## Summary of Village requirements for SCA Art Mini Park.

Meeting with Liz Melock, Mike Kaleta, Duane Boberg, Seth Wochensky and Tracy Maybray at Village Office on March 1, 2022 at 8:30 am.

Site drawing dated 10/25/2021 was reviewed.

# The Arts Mini Park

032122 A.1

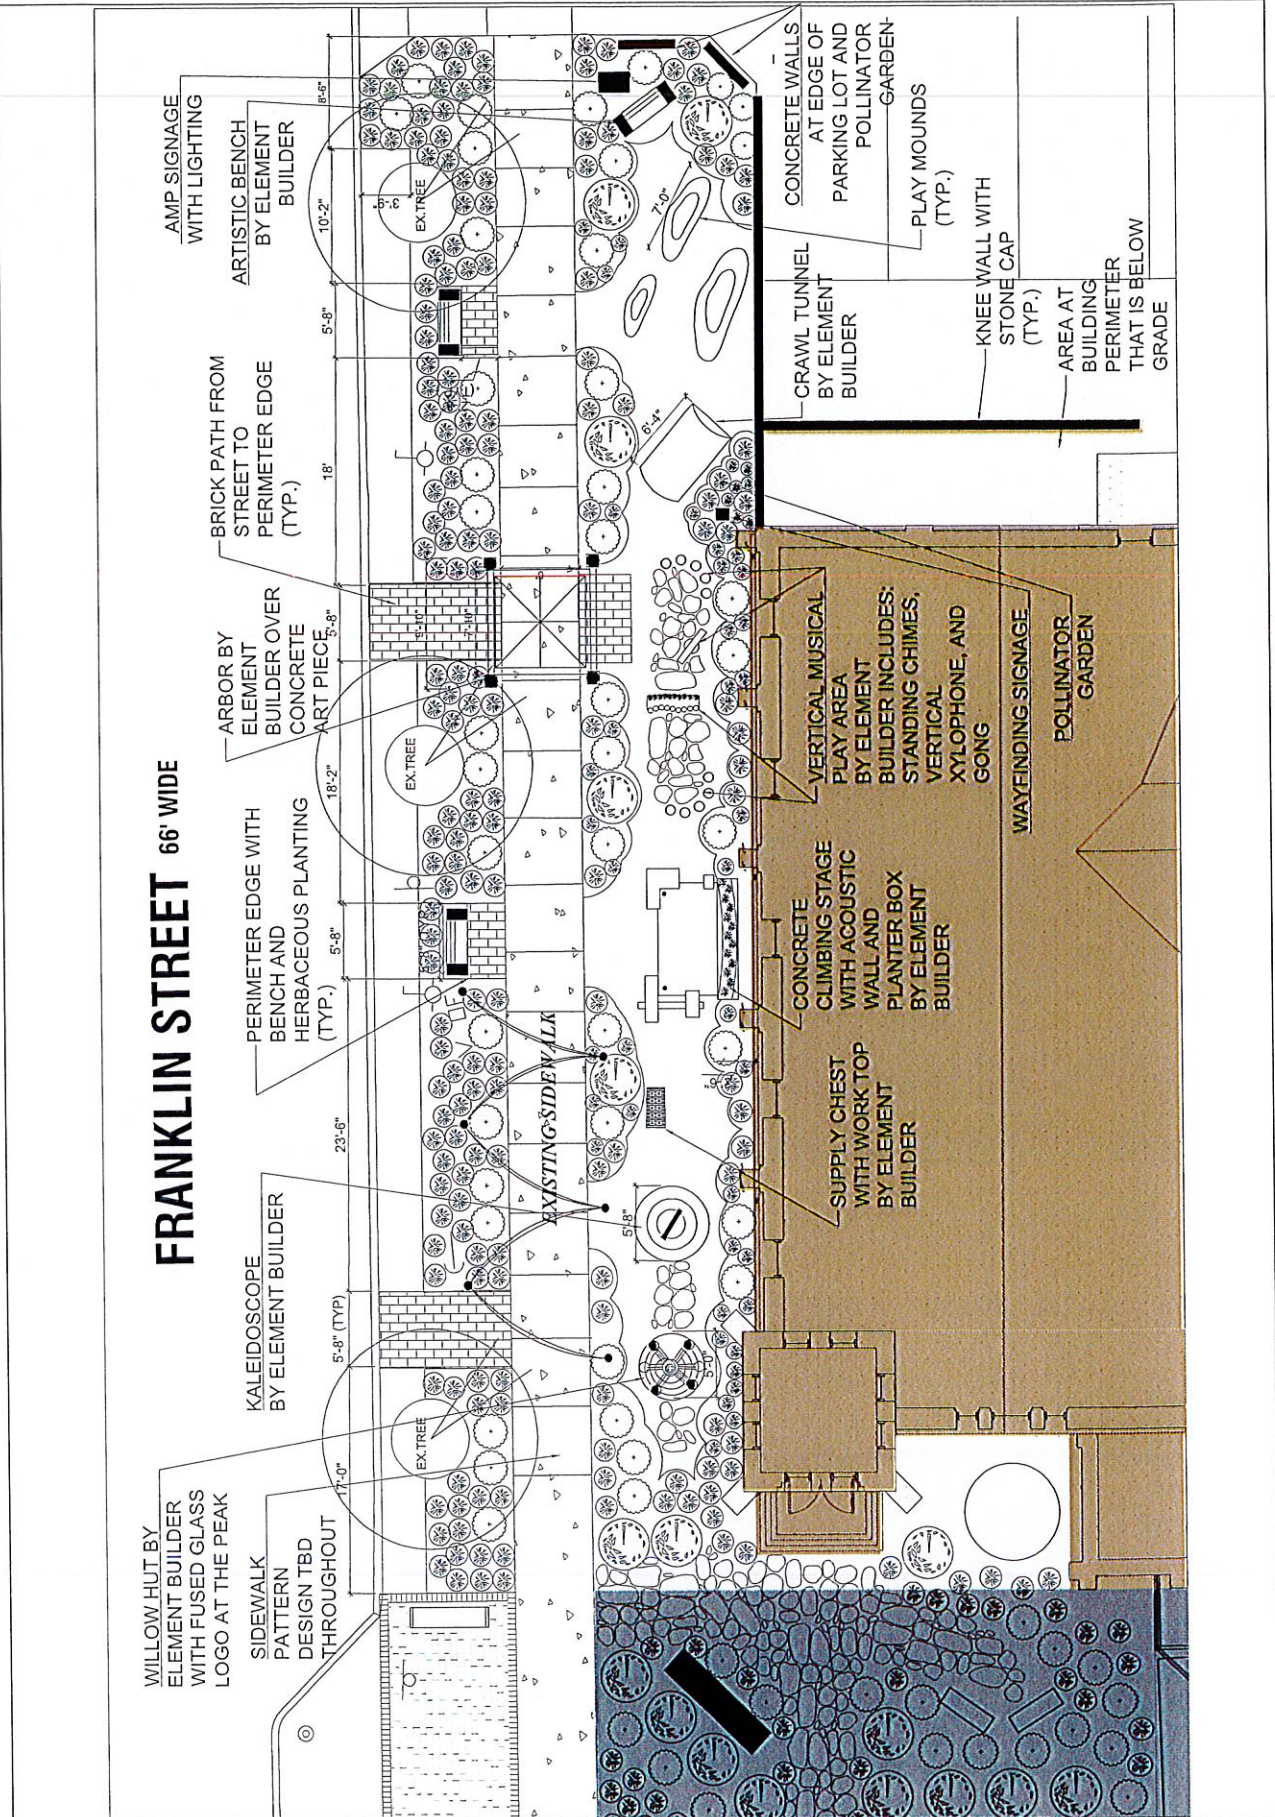
1. Sidewalk is only four (4) feet. The village requires 5 ½ - 6 feet clearance for the sidewalk plow and snow storage. No plantings, benches, removable arch, musical elements are allowed to be in the required clearance area of the sidewalk.

2. Benches in the right of way (north side of sidewalk) must be removed from the period of Nov 1<sup>st</sup> or earlier if we have snow till April 1<sup>st</sup> each year.

3. Arch over the sidewalk must have a clearance of eight feet in height and the width of the sidewalk so nothing impedes movement on the sidewalk.
4. The arch must be removed from the period of Nov 1<sup>st</sup> or earlier if we have snow till April 1<sup>st</sup> each year.

5. Brick paths must be flush with the ground to allow clearance of the sidewalk plow.
6. Plantings in the right of way must be maintained by SCA to remove weeds and not have the area become overgrown. The Village pays for the beds on Franklin to be groomed as this area needs to be maintained to not detract from the beds with weeds growing through the ground cover.

7. Sidewalk on Franklin between SCA building and right of way can be dyed but no paint can be applied. Sidewalk must not be slippery.
8. Water box – on Franklin St – Village Water Dept to move to grade level.

9. Guy wire off village utility pole on Franklin St will have a yellow safety collar (bollard) installed on it by Village Electric Dept.

On drawing submitted by Seth dated 3/8/2022 we need clarification on the arches drawn across the sidewalk to the north of kaleidoscope. What is this as it was not on the drawing presented at the meeting on March 1, 2022.
